SITE PLAN REVIEW

Owner: Aubuchon Reality Company Inc. 23 West Main St. Westminster MA. 01473	Applicant: Tyler Sterling for Hannaford Bros. Co.
Surveyor/Engineer: O’Leary Burke Civil Associates 1 Corporate Drive Essex Jct. Vt.	Property Tax Parcel: 20-50-74 .000

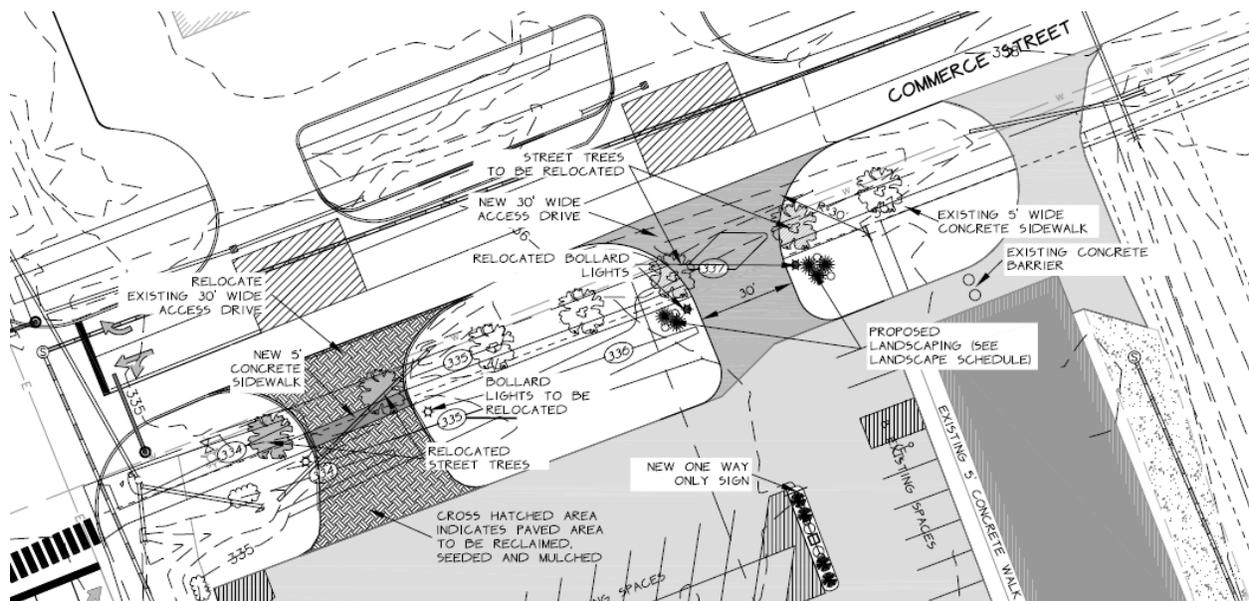
The traffic flow will remain one way, in a circular pattern around the center parking area and the parking layout will remain the same. Mike Anthony (Town Road Foreman) has reviewed the plans and sees no issues for a future curb cut application.

Provisions for refuse storage and disposal, snow removal, and emergency access shall also be addressed where applicable. The Hinesburg Fire Department has no issues with this proposal. It is laid out so that semi-tractor trailers can make all turns. It will not eliminate any parking spaces that currently exist. There is basically no difference between the flow now and what will occur if the new entryway is approved and the current one eliminated. The ease of access and egress may be improved because some of the more intense traffic closer to route 116 will be avoided. There is ample room for snow storage and no changes are proposed for refuse storage.

character of the neighborhood. Two existing street trees will be relocated along Commerce Street to accommodate the new access drive and be placed where the current drive is located. these trees should be replaced instead of moved if not an approved street tree variety, or in good health. If they fail because of the move, the replacement should be a larger caliper than what is usually required (3"?) so that not too much time is lost for the tree to regain the stature that exists now. The applicant is proposing to comply with the required landscaping budget by planting new shrubs locate on the east and west sides of the new access drive near the relocated bollard lights.

There is a culvert under the existing commerce street delivery entrance that, based on an interpretation of the submitted plan, is designed to flow to the east starting an approximately 337 elevation and connecting to the system that drains commerce park under commerce street at an elevation of something less than 335 feet. This culvert presently serves as an unapproved

“safety valve” for flooding events, allowing the flood water that can’t pass under Commerce Street to flow backward, to the west, along Commerce Street and eventually along 116 and north to Patrick brook. Dark Star properties appears to be at an elevation of approximately 337 feet, indicating the possibility that if this safety valve is eliminated flooding on the Dark star property may worsen.

There is no culvert proposed under the new driveway entrance since the water can flow to the west as it does now. Any water to the east of the new entrance can flow through the culvert under the service entrance as it does now. The issue is that by stopping the backwards “safety valve” flow it may worsen the situation at Darkstar. I imagine that intentionally installing the culvert under the new driveway will take an amendment to the Commerce Park storm water permit since that backward flow is not currently permitted.

No construction of this new entrance should occur until the issues with the current culvert under Commerce Street have been corrected so that this “safety valve” is not necessary.

The second issue is that parking lots are a major contributor to non-point pollution of our waterways. There is no retention or treatment of the stormwater flow off of the existing parking area other than unorganized flow over some grass. The proposed elimination of the western curbcut provides an excellent opportunity to improve this situation. The existing raised platform for the current driveway should be removed so that the culverts (now partially clogged) can be eliminated. There is an area of grass between the existing pavement and the bottom of the swale that runs along Commerce Street. With the existing driveway removed there would be an area of approximately 160 feet long by 20 feet wide which provides an excellent opportunity to detain and cleanse the runoff from the parking lot.

I suggest that this hearing be continued specifically so that the applicant can investigate the various methods that could be utilized in this area and come back with a plan that utilizes this area for stormwater control and treatment. It should capture as much of the existing flow from the parking lot as is possible, utilizing curbing to direct the water if necessary.
